**Subject:** Virgil C. Summer Nuclear Station (VCSNS) Units 2 and 3  
Docket Numbers 52-027 and 52-028  
Response to Requests for Additional Information related to Preservice Inspection  
Requirements for Steam Generator Nozzle to Reactor Coolant Pump Casing  
Welds

Enclosure 1: Virgil C. Summer Nuclear Station (VCSNS) Units 2 and 3 – Response to NRC Staff Request for Additional Information (RAI) Regarding Preservice Inspection Requirements for Steam Generator Nozzle to Reactor Coolant Pump Casing Welds

**NRC RAI Response Regarding Inspection of *AP1000* Vogtle Units 3 & 4  
and V. C. Summer Units 2 & 3 Steam Generator to Reactor Coolant  
Pump Suction Nozzle Weld**

Figure 2: Crack Growth Chart for the *AP1000* Steam Generator to Reactor Coolant Pump Suction Nozzle  
Dissimilar Metal Weld, Outside Surface Axial Flaw with Aspect Ratio = 2

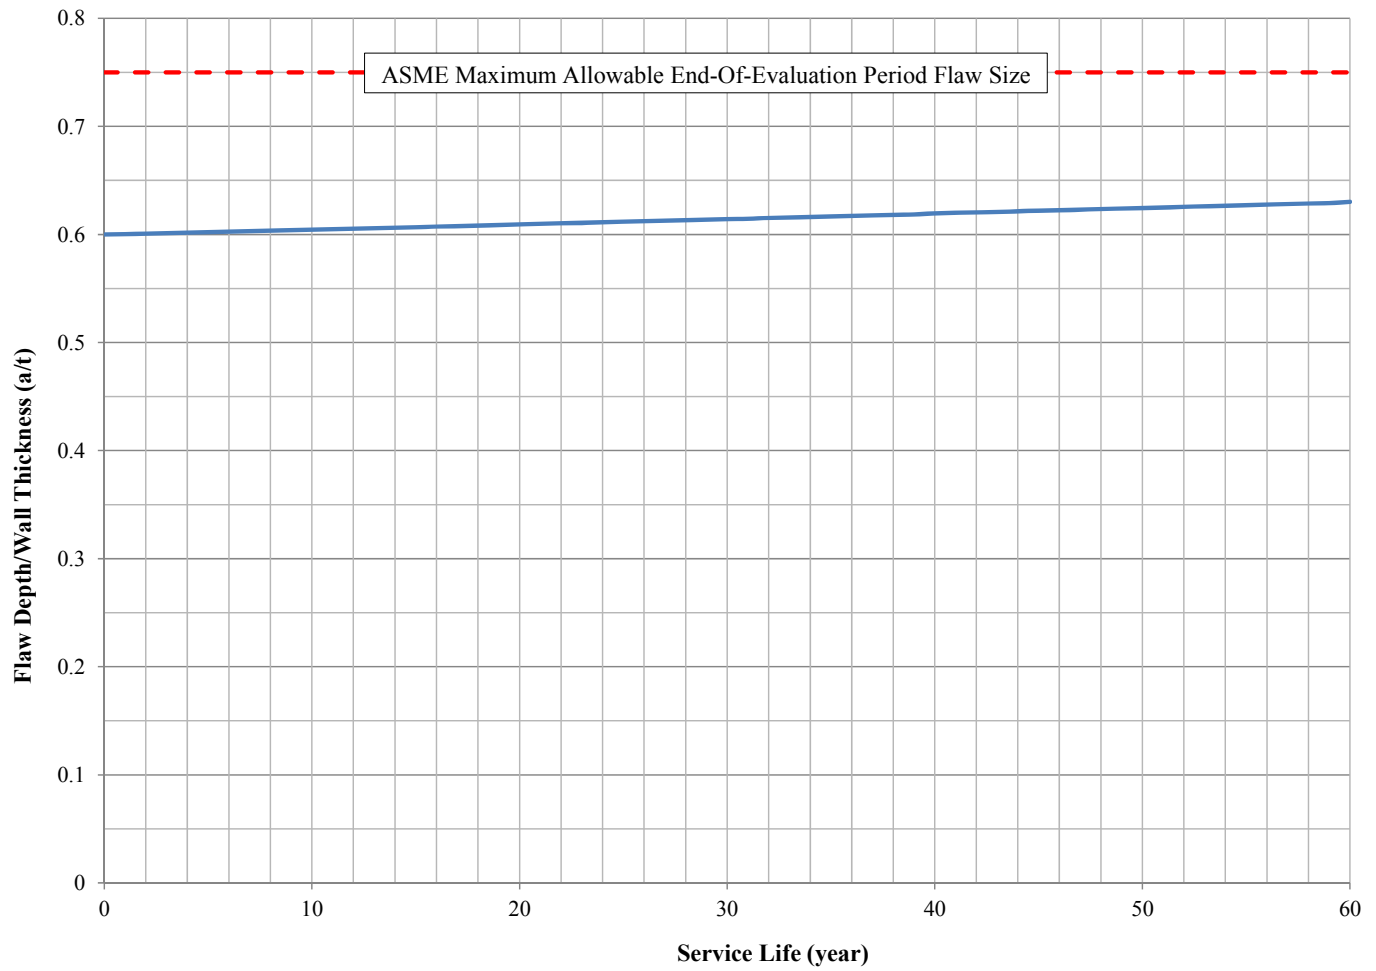
To resolve this issue, the staff requests that the licensee provide additional information or analyses to justify why the proposed examinations are an acceptable alternative to examining the full weld volume. Specifically, the staff requests that the licensee, at a minimum, provide an analysis which considers the size and nature of the largest potential defect which could be expected to be present in the outer 2/3 of the weld as well as the operating loads to which the weld will be subject for the licensed lifetime of the facility. To support the requested alternative, this analysis would be expected to demonstrate that the initiation of active degradation of the weld would not be expected to occur from the postulated defect in the outer 2/3 of the weld over the licensed lifetime of the facility.

As shown in Figure 2 for an axial flaw, even a 60 percent through the wall thickness flaw would not reach the maximum allowable flaw size in 60 years. Figure 3 for circumferential flaws shows that a postulated flaw as large as 30 percent through the wall thickness flaw would not reach the maximum allowable flaw size in 60 years. Any initial axial and circumferential flaw sizes less than the 60 and 30 percent of the wall thickness, respectively, are encompassed by these curves and will not grow to the maximum allowable flaw size in 60 years. The large axial and circumferential flaw sizes described above would have been detected by initial volumetric fabrication inspections and will be detected by the regular ISI surface examinations of the outside surface of the SG to RCP suction nozzle DM weld.
